VALUE ENGINEERING STUDY

Project # CSSTP-0009-00(396)

Project # CSSTP-0009-00(397)

Atlanta Beltline Southwest and Southeast Corridors Fulton County, Georgia

PROPOSAL NUMBER: T6-5

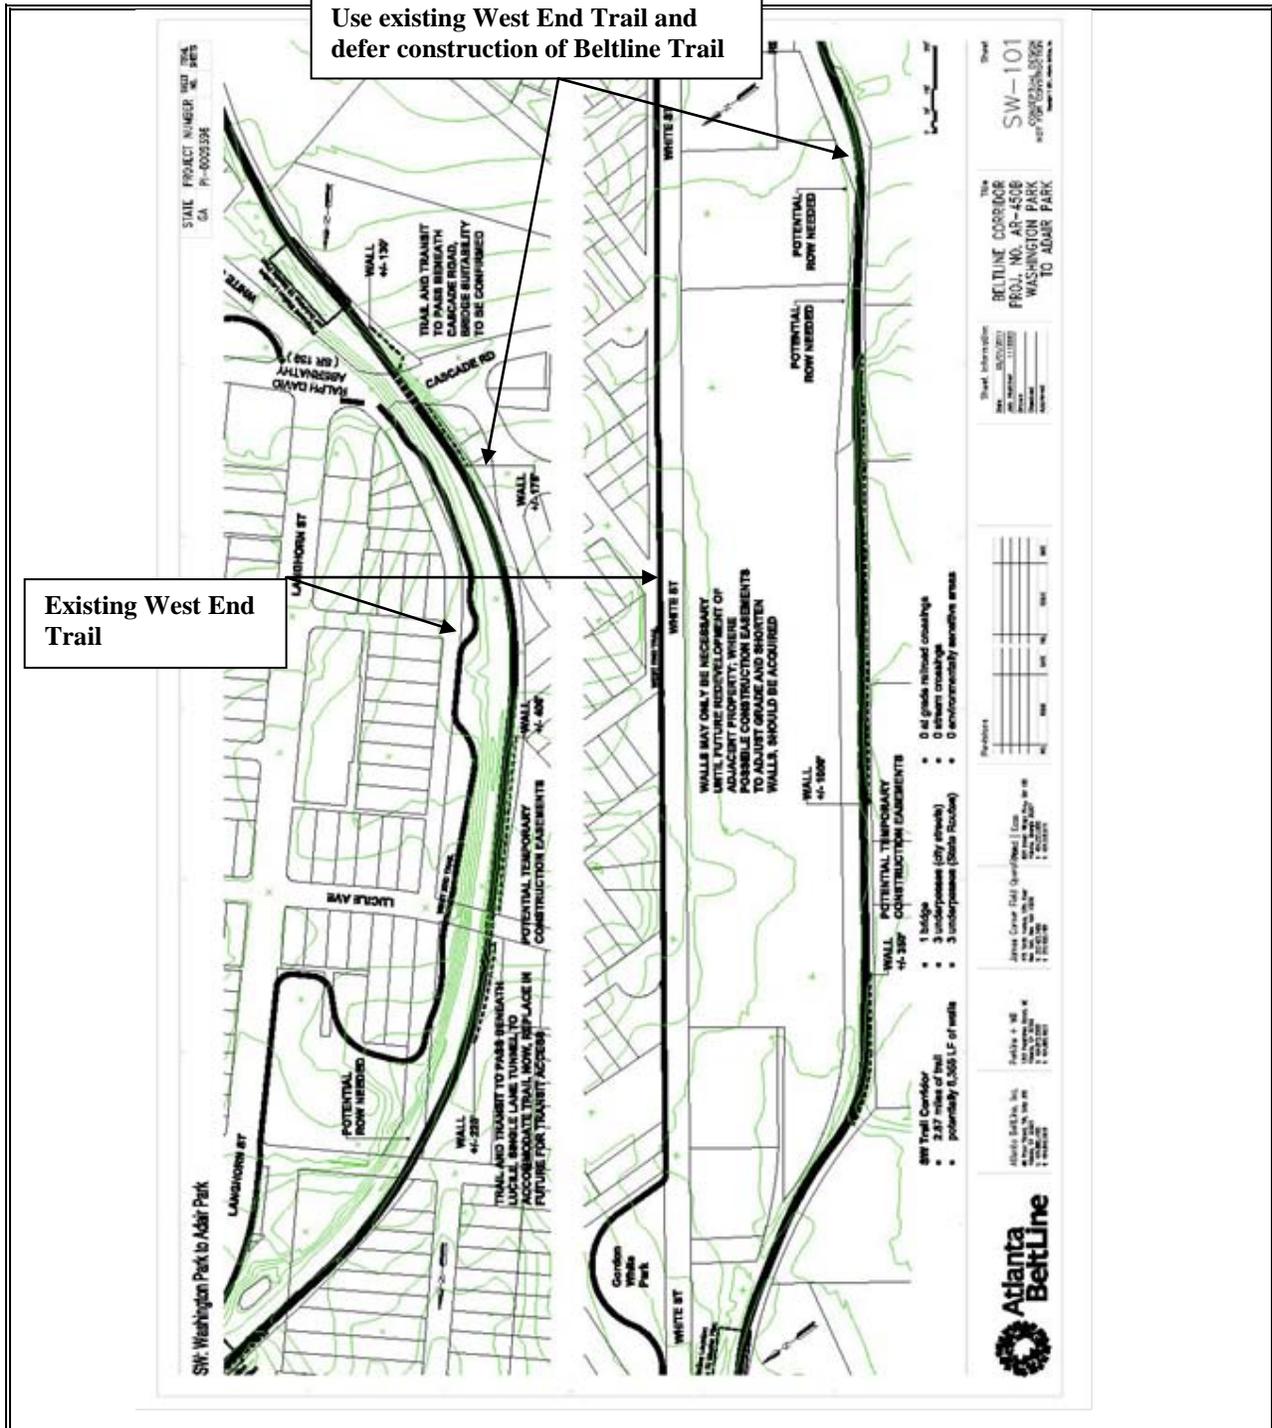
PROPOSED CHANGE: It is proposed to utilize the existing West End trail beginning at I-20 and extending to Lawton Street and defer construction of the new trail and all required improvements until the transit line is constructed. Extending the use of the existing West End Trail beginning at I-20 defers construction of 3,460 LF of trail until the transit is constructed.

PROPOSAL NUMBER: T6-10

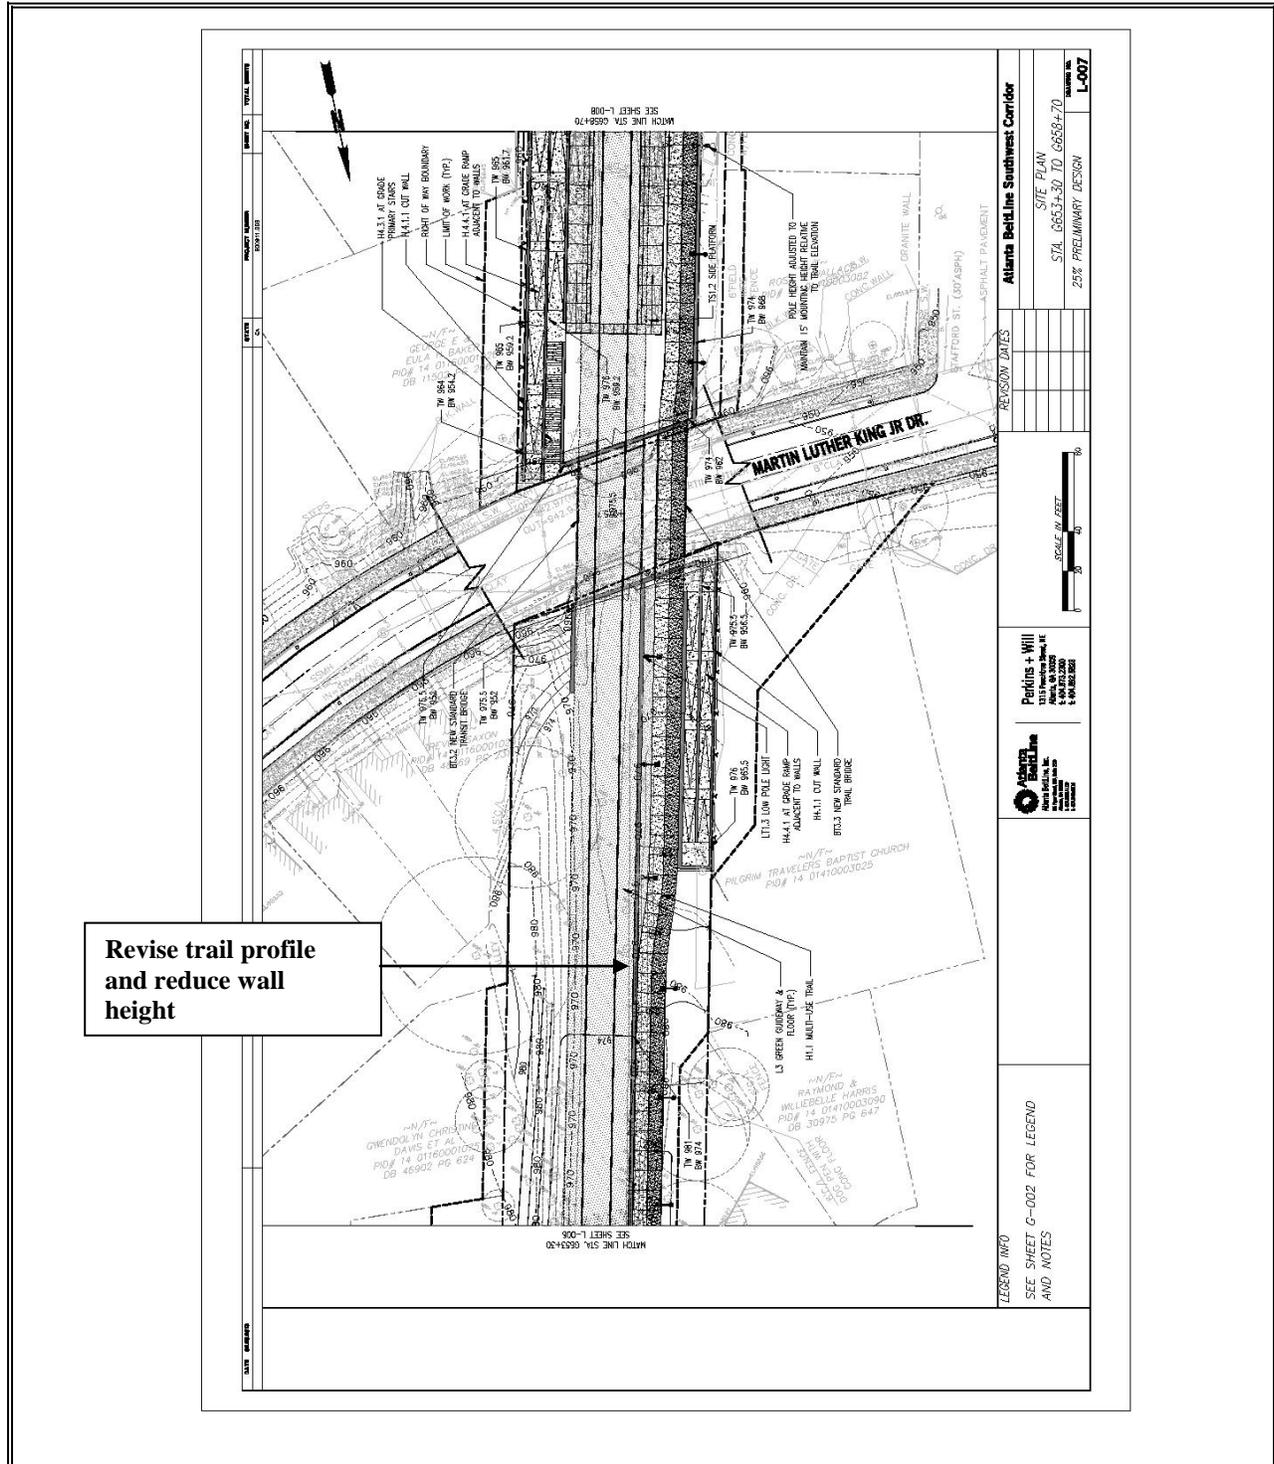
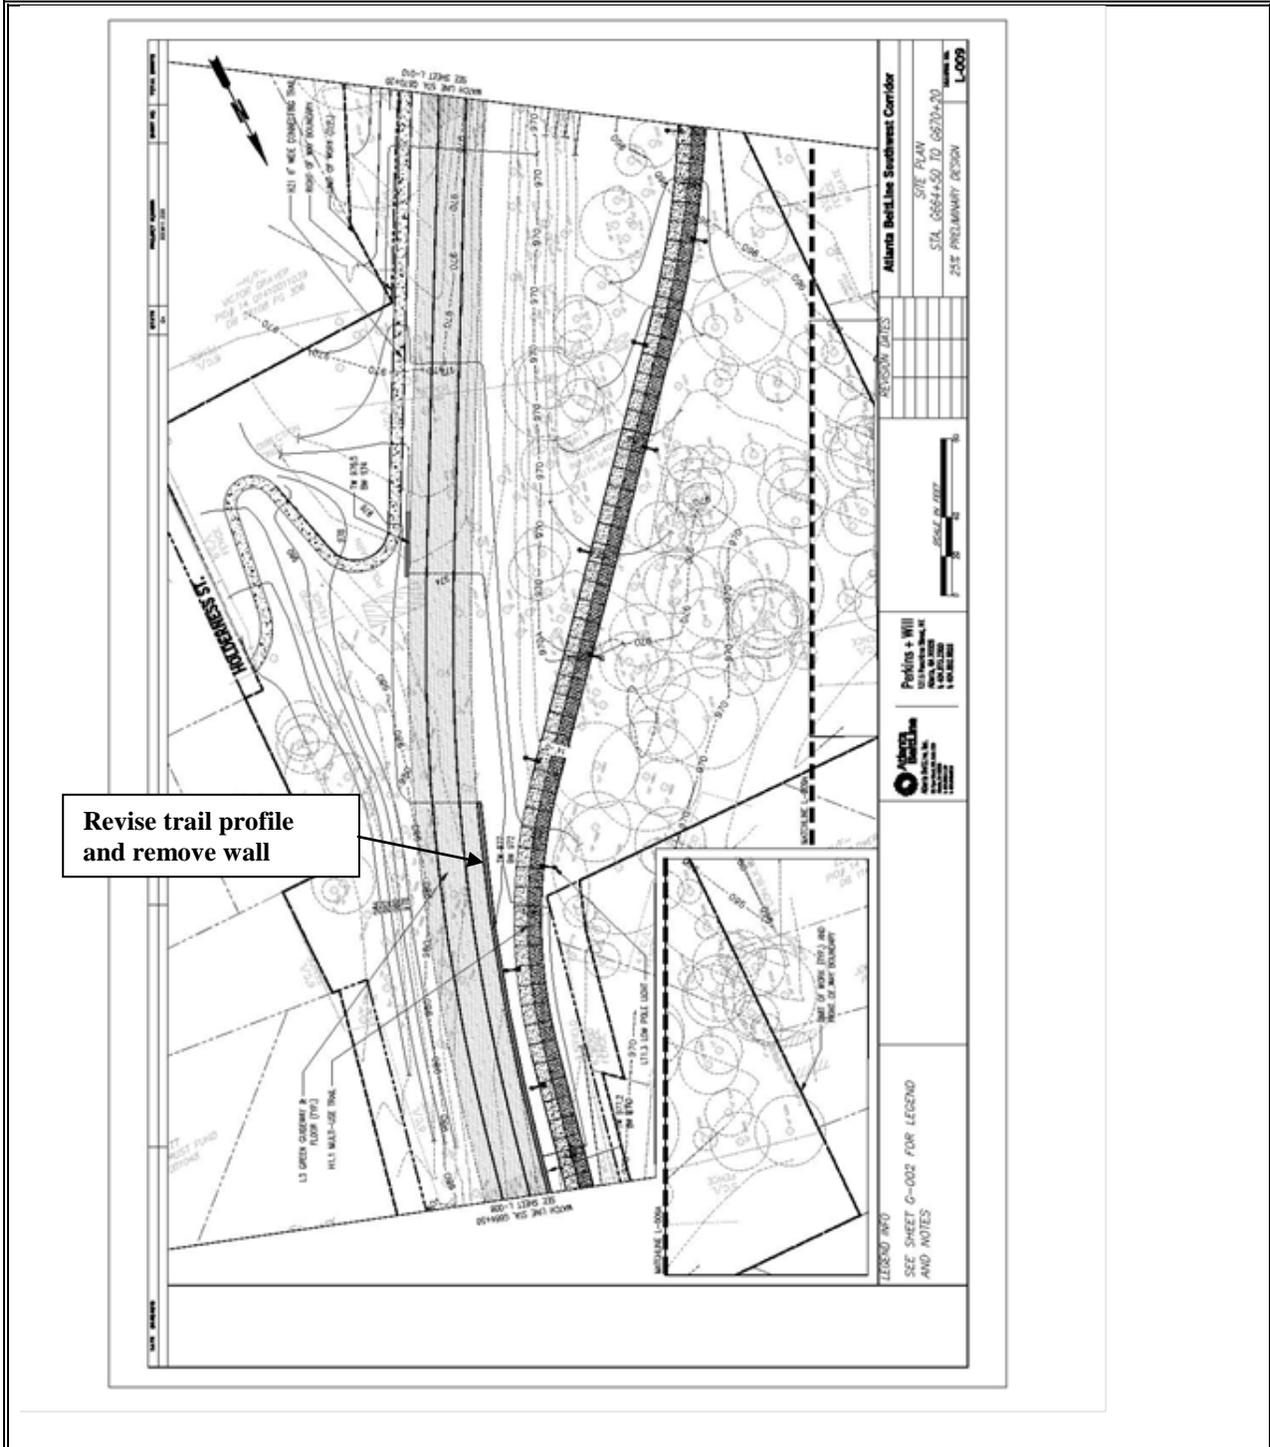
PROPOSED CHANGE: It is proposed to revise the trail profile in areas to eliminate the wall between the transit and trail. As identified in the Calculations sheets within this proposal, there are 3 locations where this proposed alternative could be implemented and result in elimination of 550 LF of walls.

**Revise trail profile
and reduce wall
height**

PROPOSAL NUMBER: T6-11

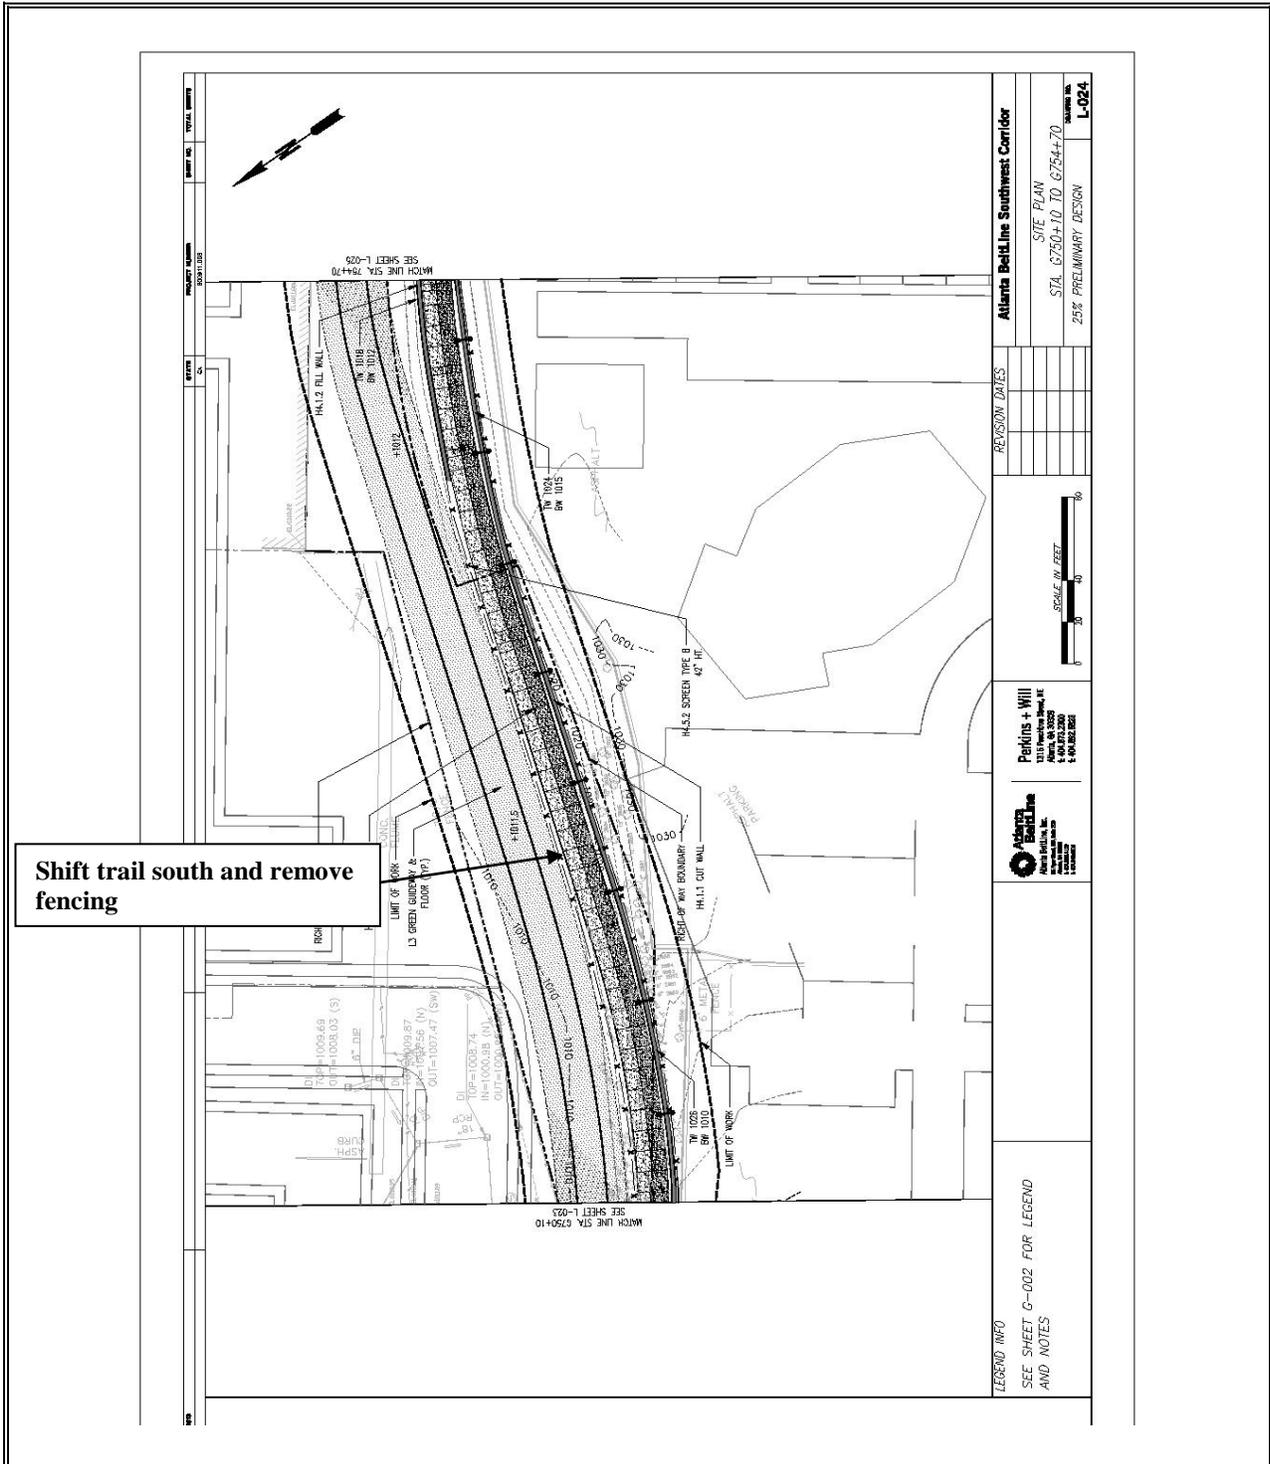
PROPOSED CHANGE: It is proposed to separate the trail from the transit by the 5' minimum distance in order to eliminate fencing between the trail and transit. As shown in the Calculations sheets within this proposal, there are 2 locations where this proposed alternative can be implemented and results in an elimination of 700 LF of separation fence.

Shift trail south and remove fencing

PROPOSAL NUMBER: T7-1

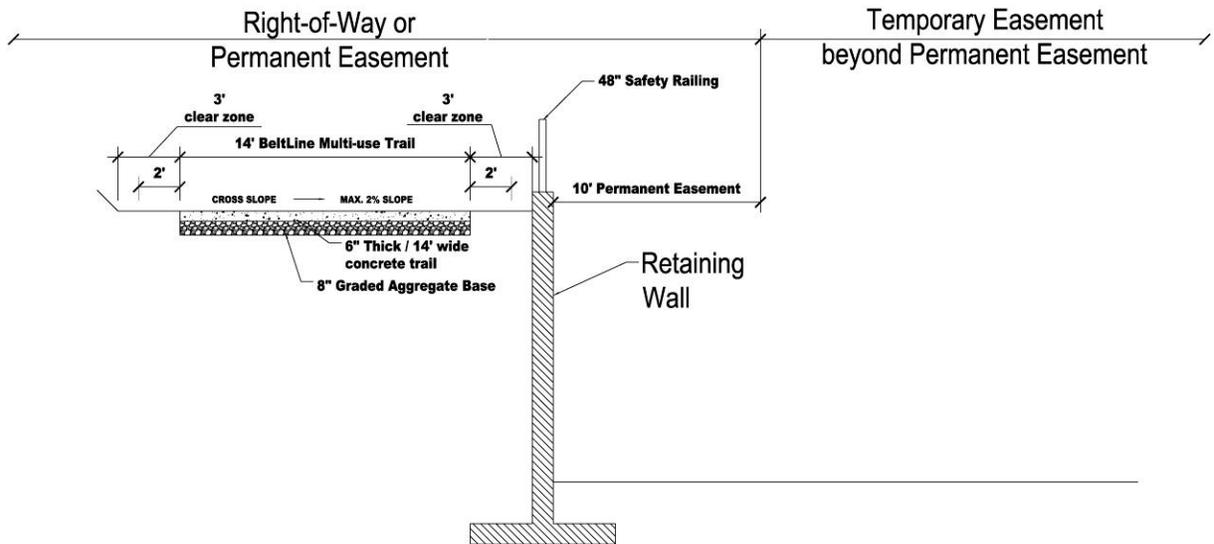
PROPOSED CHANGE: In areas where retaining walls are to be implemented, utilize a permanent easement beyond the face of the walls at a width of 10-feet for fill walls and a width of 1.5 times the height behind the face of cut walls. Utilize temporary easements to accommodate the remainder of the limit of work area beyond these permanent easements.

PROPOSAL NUMBER: T7-2

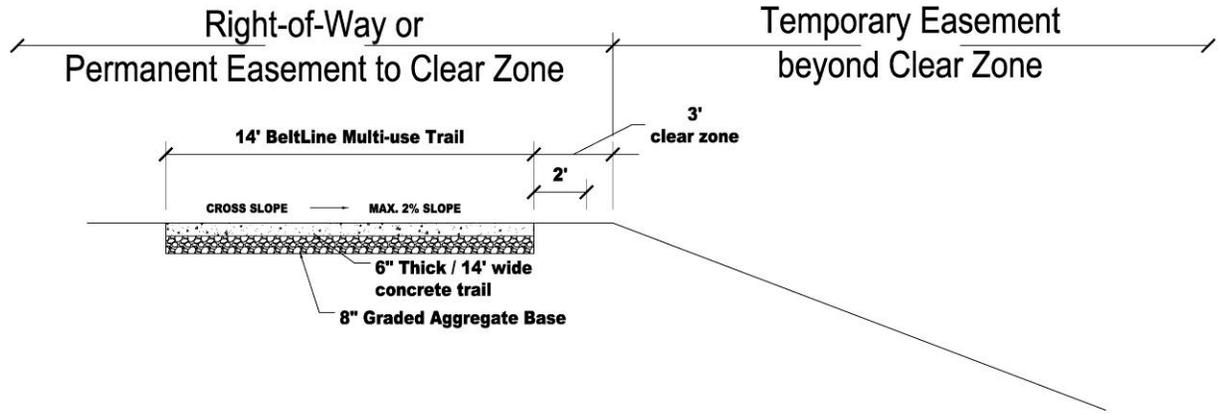
PROPOSED CHANGE: In areas where cut or fill slopes are to be implemented, utilize a permanent easement to the clear zone (3-foot from trail edge). Utilize temporary easements to accommodate the remainder of the limit of work area beyond these permanent easements.
